Technical Bulletin 157 - Hydraulic Separation Required for Rinnai Boilers

Purpose: To announce that hydraulic separation between the boiler and heating system is required for the I-Series and M-Series Condensing Boilers (models shown in tables below).

CORRECT Piping With Hydraulic Separation

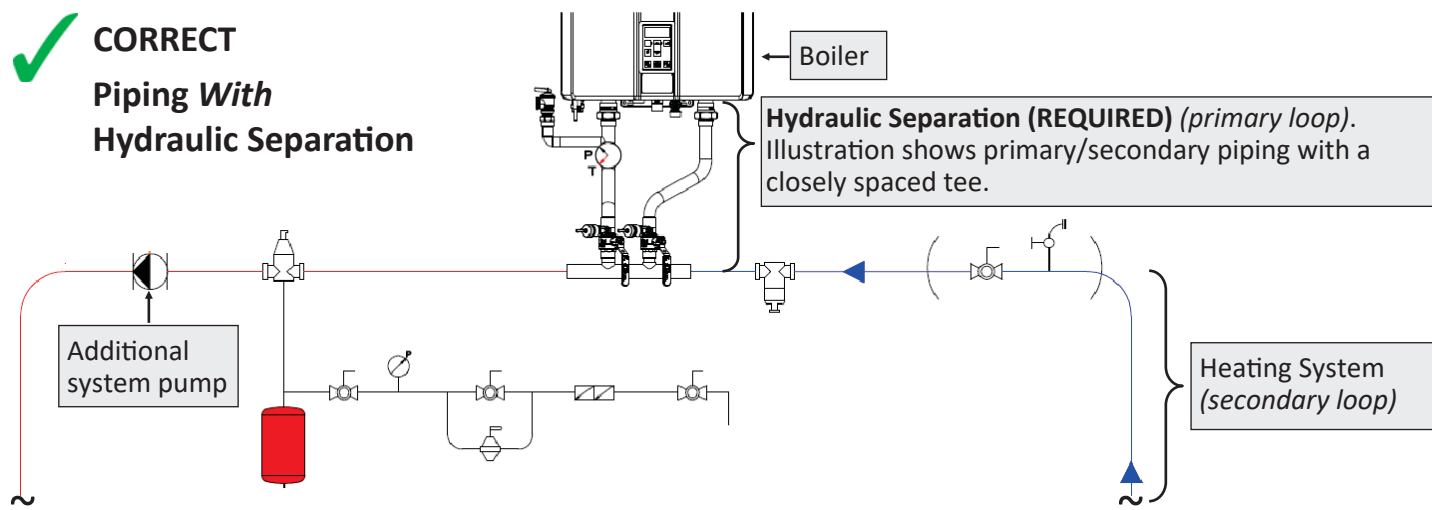
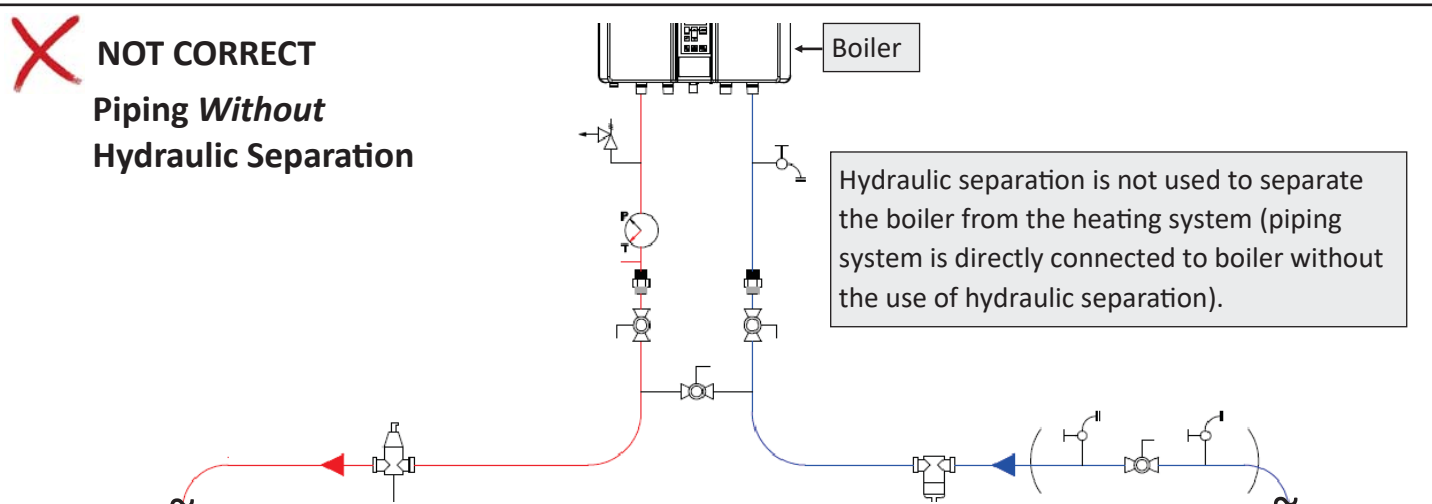
About Hydraulic Separation: Hydraulic separation uses primary/secondary piping to separate the boiler from the heating system. Primary/secondary piping creates two connected loops: a primary loop for the boiler and a secondary loop for the heating system. The boiler loop is connected to the heating system by closely spaced tees or a low loss header (illustrations on next page). **Important: Additional pump(s) are required when using hydraulic separation.** Directly connecting a boiler to a hydronic heating system (without using hydraulic separation) may cause high pressure losses and low flow conditions within the heating system, thus limiting the performance of the boiler and heating system. Hydraulic separation using primary/secondary piping helps minimize the potential of operational errors while increasing flow and improving system and boiler performance.

The images below are not complete piping diagrams; they do not show all valves or piping components. The images are intended to show piping with and without hydraulic separation. Refer to the Boiler Installation and Operation Manual for complete piping diagrams.
